MIL-P-49378 (AR)
AMENDMENT 1
03 January 2000

MILITARY SPECIFICATION

POWER CONVERTER FOR AN/VSG-2

This Amendment forms part of MIL-P-49378, dated 16 June 1980, and is approved for use by the US Army Armament, Research, Development, and Engineering Center, and is available for use by all Departments and Agencies of the Department of Defense.

Figure 1. Transient Voltage Levels.

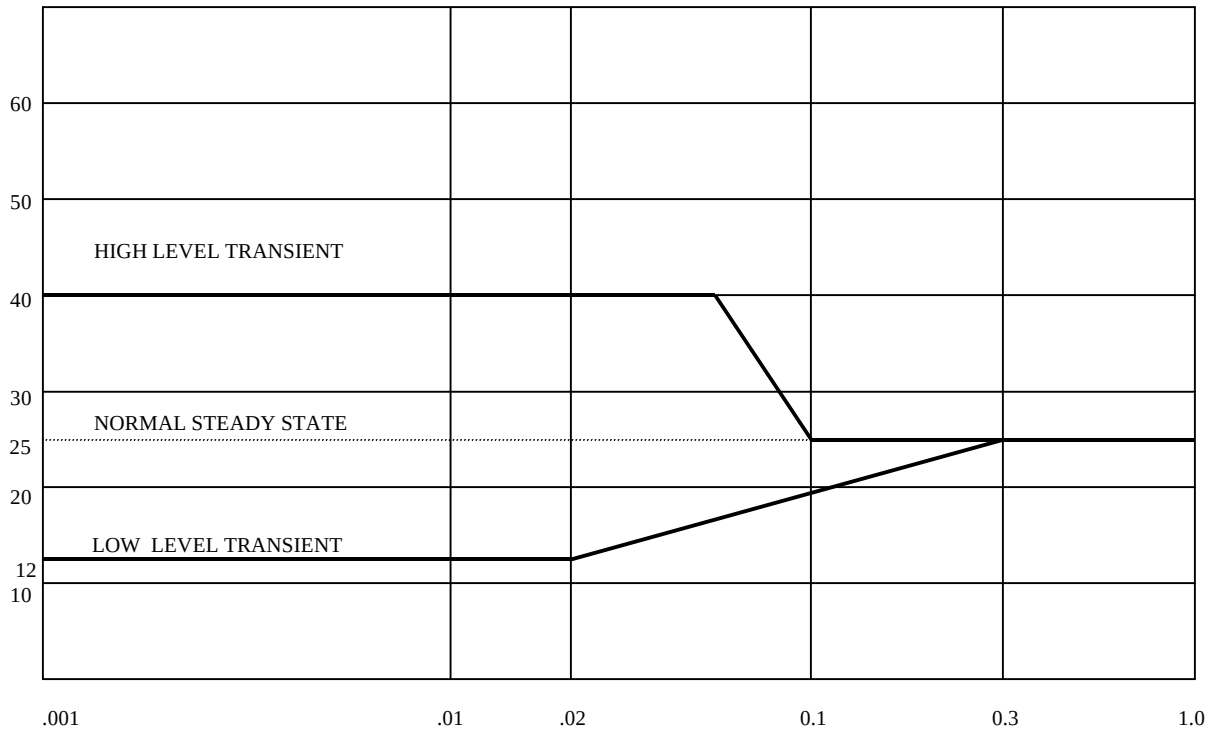
Figure 1 : Delete in its entirety and substitute:

3.7.9.1 Transient voltage input: The Power Converter shall operate in accordance with paragraph 3.7.4 and 3.7.5 during the transient voltage defined in Figure 1 applied at the input connector 4J1.

4.7.9.1 Transient voltage. The Power Converter shall operate in accordance with paragraphs 3.7.4 and 3.7.5 during the transient voltages defined in Figure 1 applied at connector 4J1.

Figure 2. Severe Transient Voltage Levels.

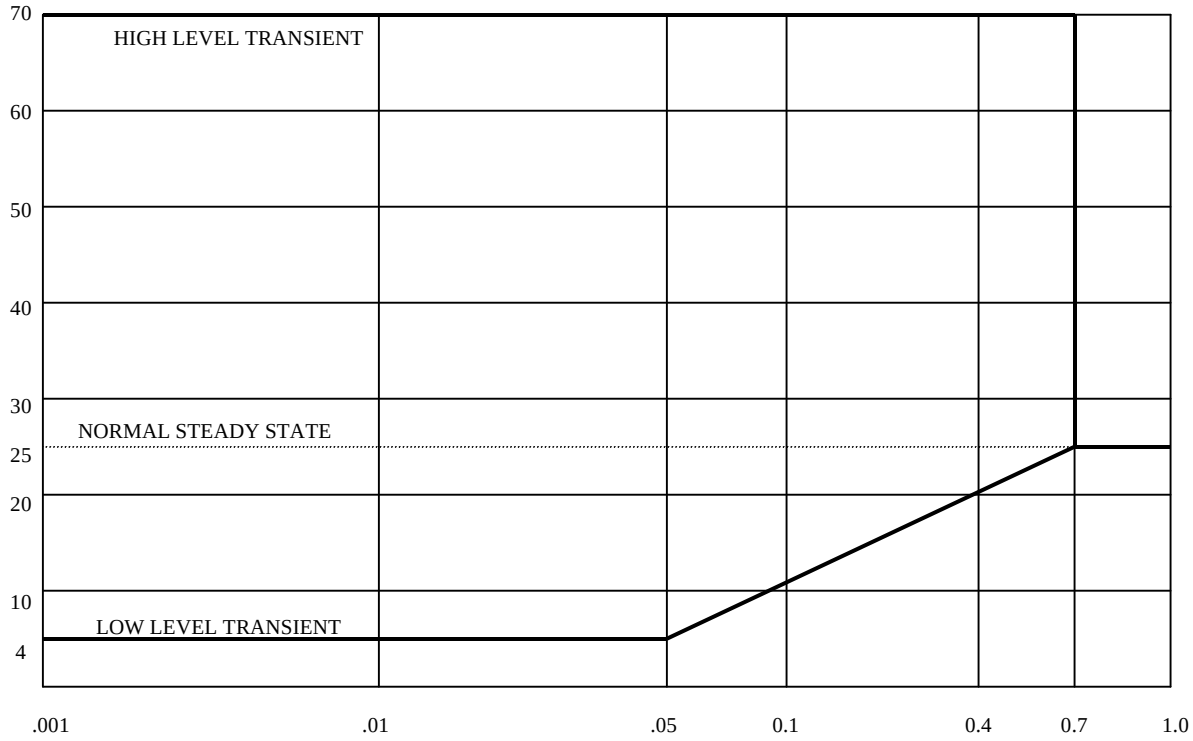
Figure 2 : Delete in its entirety and substitute :

3.7.9.2 Severe transient voltage input: The Power Converter shall not be damaged by the transient voltages defined in Figure 2 applied at the input connector 4J1, and shall operate in accordance with paragraphs 3.7.4 and 3.7.5 following reset of the circuit breaker."

4.7.9.2 Severe transient voltage. The Power Converter shall not be damaged by the transient voltages defined in Figure 2 applied at the input connector 4J1 and shall operate in accordance with paragraphs 3.7.4 and 3.7.5 following reset of the circuit breaker."
